**Gallagher Tract 30" & 24" Sewer Extension**  
**Solicitation Number: CO-00609**  
**Job No.: 21-4407**

**ADDENDUM 1**  
**November 14, 2022**

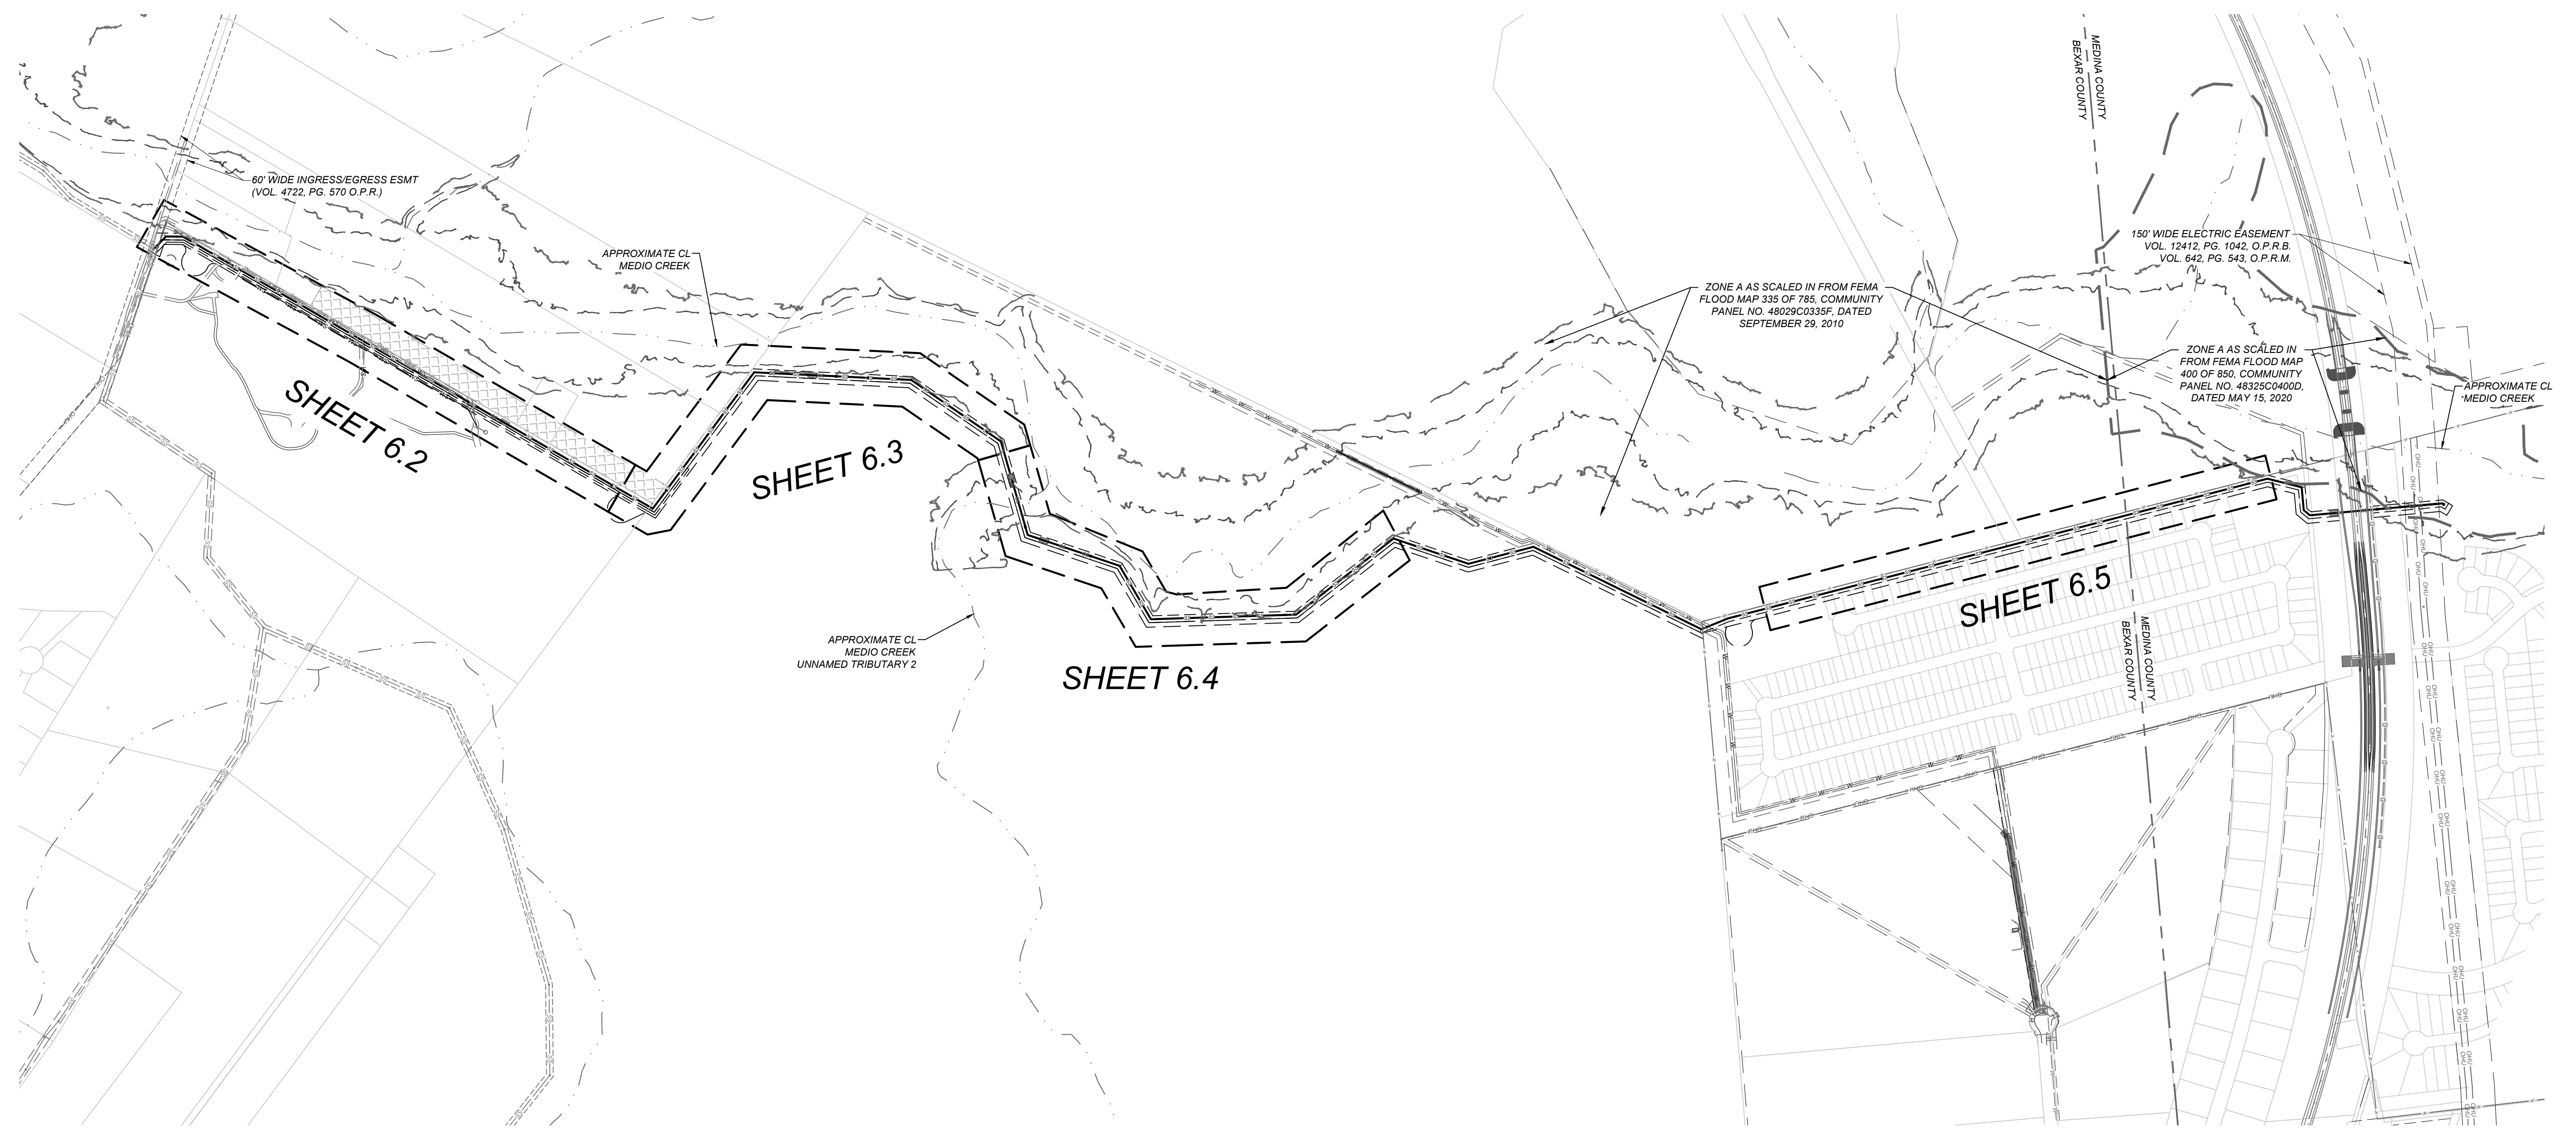
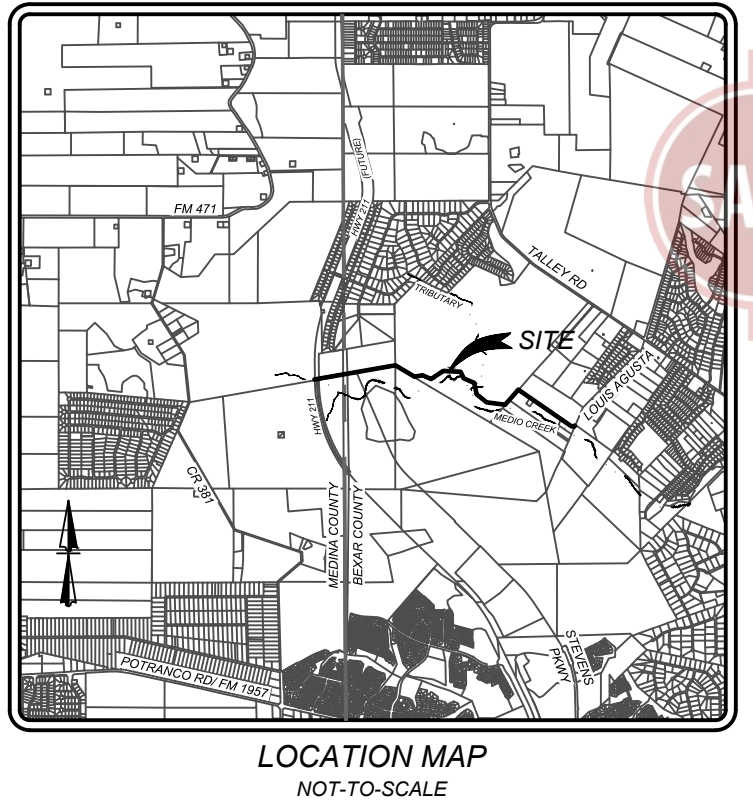
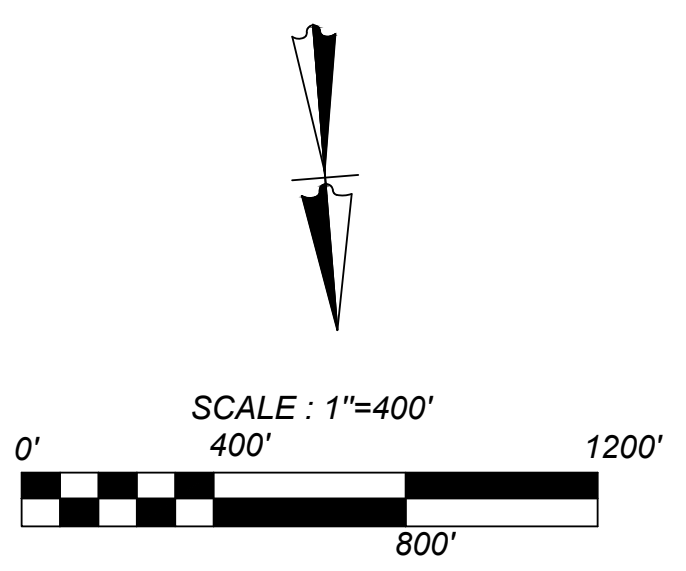
*Answer: A line item (#70) on the bid proposal has been added to capture the material for the Tee-Based Manholes ring & covers. In addition, the overall quantities on sheet 0.1 "General Notes and Quantities" has also been updated to reflect this. See #1 Changes to the Plans.*

1. Sheet 0.1 (General Notes and Quantities )-Remove Sheet 0.1 in its entirety and replace with revised version attached to this addendum
2. Sheet 6.0 (Tree Preservation Sheet Index)-Remove Sheet 6.0 in its entirety and replace with revised version attached to this addendum
3. Sheet 6.1 (Tree Preservation Plan Tables)-Remove Sheet 6.1 in its entirety and replace with revised version attached to this addendum

1. The revised bid proposal and sheet 0.1 were updated to include the quantities for ring & covers for the 5' Tee-Base Manholes.
2. Sheets 6.0 & 6.1 were updated to include the City of San Antonio approved and stamped tree plans.
